Change of packaging material for SFP Transceivers (valid for SFP transceivers for use with switches of Eco-, Advanced-, Substation and BasicLine series B)

- PCN-number: PCN-PN48-20250305-00-A
- date of publishing: 5th March 2025
- revision number: A

Current packaging	New packaging
Clamshell blister	Paper liner

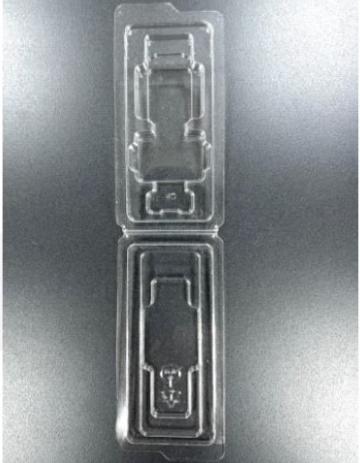
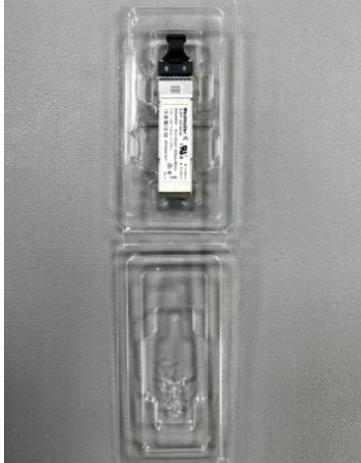
Change of packaging material from clamshell blister (PET) to paper liner to reduce plastic use.

Clamshell blister + SFP	Paper liner + SFP

Clamshell blister + SFP + Box	Paper liner + SFP + Box
